#### PHOTOVOLTAIC PROJECT

CITY HILL MIDDLE SCHOOL **441 CITY HILL STREET** NAUGATUCK, CT 06770 STATE PROJECT #088-0075 PV

S/P+A PROJECT NO. 19.208

**DATE:** July 21, 2020

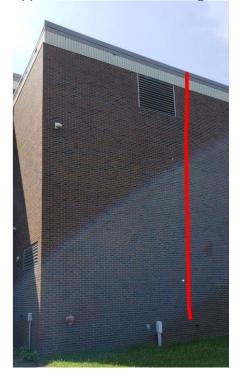
6. One-Line Diagram does not appear to show the correct wiring sequence.

- A. The system shall be wired cold sequenced to the load side. Eversource has strict requirements which will need to be met and coordinated with throughout the project.
- 7. When opening the switchgear, it was apparent that the buss has already been tapped, but there is no clear sign that UL has re-certified the gear, how should we proceed?
  - A. The response to this is conditioned upon inspection of switchgear buss tap and further review of that inspection.
